**STATE OF HAWAII**  
DEPARTMENT OF LAND AND NATURAL RESOURCES  
DIVISION OF FORESTRY AND WILDLIFE  
1151 PUNCHBOWL STREET, ROOM 325  
HONOLULU, HAWAII 96813

SUBJECT: Comments on Alexander and Baldwin, Inc. applications for stream diversion works permits for abandonment.

Figure 4. Stagnant water standing in depressions created by the walls and the gate structure.

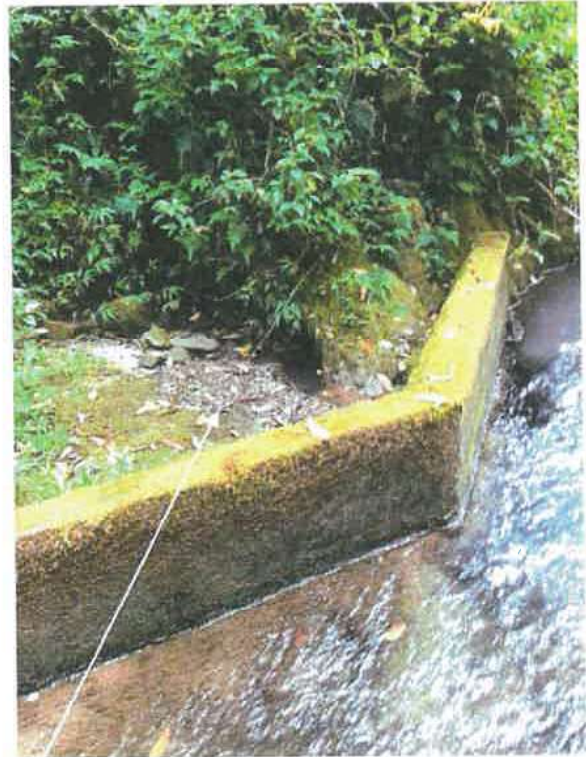
(b) Walls on both sides of the stream prevent the stream water from taking its natural course. The walls create sections where water stands and cause pooling of water, which becomes stagnant and creates breeding sites for mosquitoes.

(c) Water is also standing and foul in the sluice basin or catchment entry structure where the gate is located.

(a) In addition to the measures identified in the application to seal the grate, remove the walls to restore the natural stream flow and eliminate mosquito breeding sites.

(b) Prevent stagnant water and mosquito breeding sites sealing the sluice basin or other measures to avoid water standing in the structure.

Figure 6. Location where tributary will cross the access road.

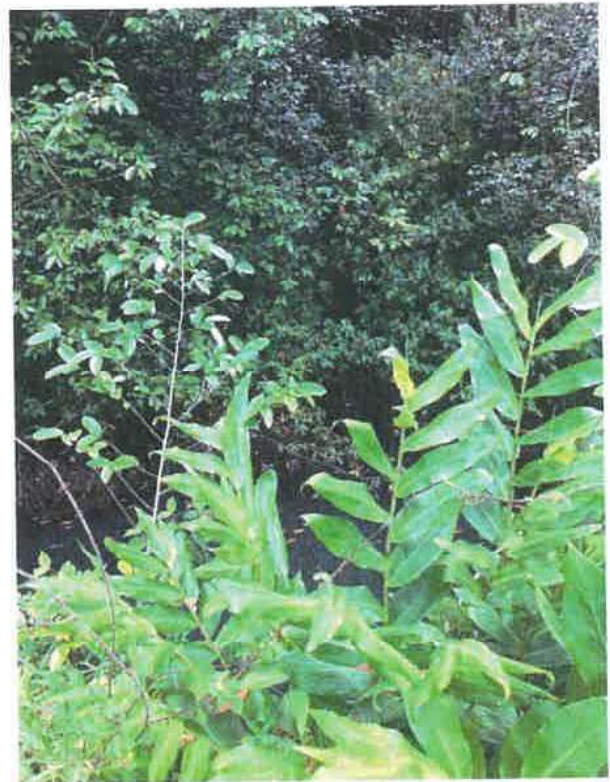
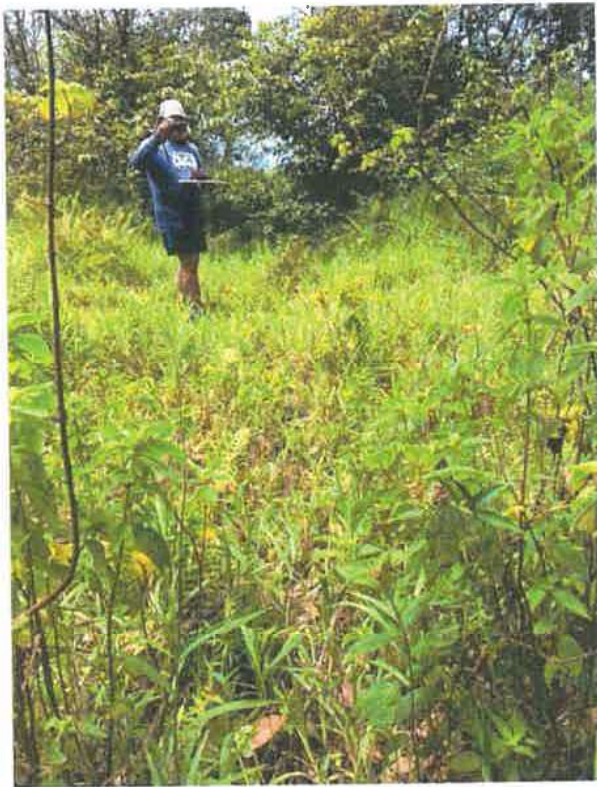
(b) This tributary enters the New Hamakua ditch where the access road runs along and makai of the ditch. The application proposes to install a stream bypass to enable the tributary to cross over the ditch.

(c) The stream must also cross the road and the application does not describe how that will be constructed.

(a) The methods employed to enable the stream to cross the road should ensure that erosion of the road is avoided. This may be done by installing a concrete swale or by installation of a culvert of appropriate diameter under the road.

Figure 8. East Wailuanui at Koolau ditch (K-18). Stagnant water outside the west wall (top left), wall crossing stream (top right), stagnant water on the east side of the stream.

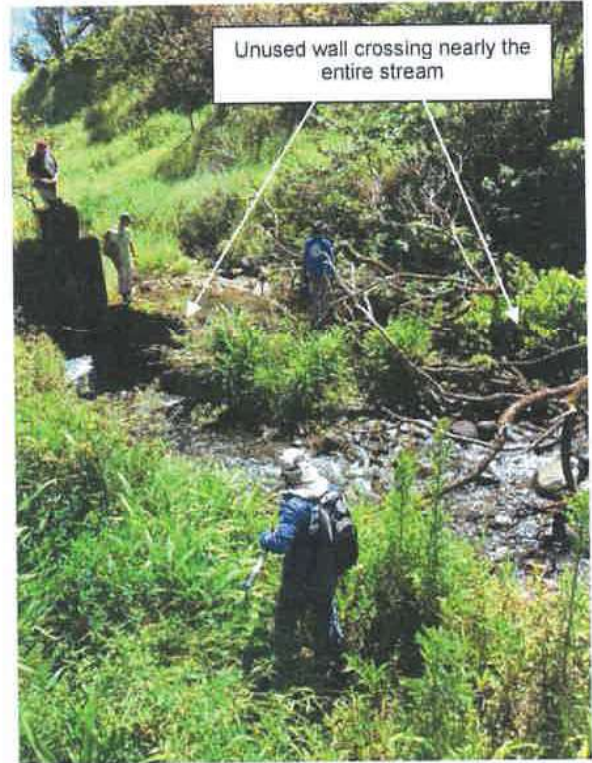
(a) This diversion consists of walls on both sides of the stream that divert the stream into the ditch on the west side of the stream. The east wall crosses nearly the entire stream bed to divert the water to the west.

(b) The walls trap standing water on both sides of the stream, as well as in the intake, which we found to be very stagnant, creating breeding sites for mosquitoes. The application proposes to permanently remove the sluice gate to restore stream flow and to fill the intake with concrete.

(a) Remove the walls on the east and west side of the stream in their entirety. Those walls will no longer be used for diversion purposes and their presence creates large areas of stagnate water that creates breeding sites for mosquitoes.

(b) Ensure that sufficient fill material is used for the intake to ensure that water does not become stagnant in the intake.

(c) Remove the pillar and structures at the intake since they will no longer be used for water diversion purposes.

Figure 9. Channel to enable stream to cross ditch (left). Control house at K-19 (right).

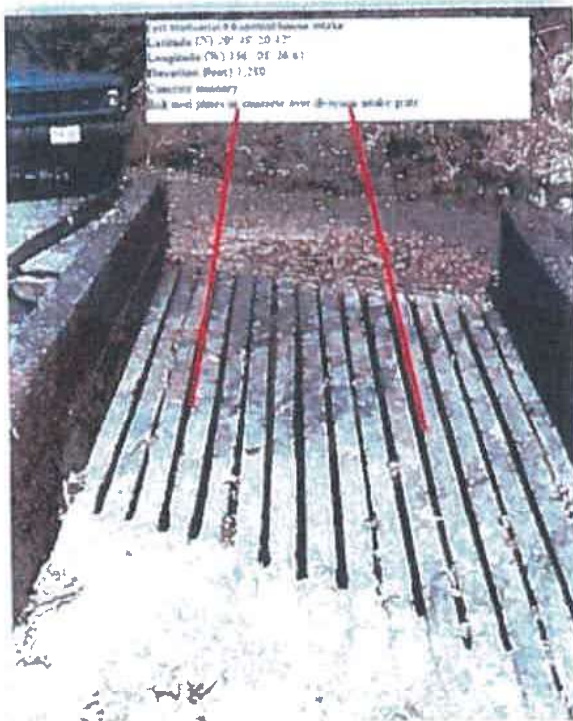
- (a) Diversion consists of walls that channel the stream flow over the ditch where a collection grate allows the water to fall into the ditch.
- (b) The application proposes to cover and seal the grate so that water will continue downstream.

- (a) The channel that is created by the walls is relatively narrow and low. It is unknown whether it may should be monitored regularly to ensure that it does not become obstructed by debris.
- (b) The control house and related structures should be removed if they are no longer in use.
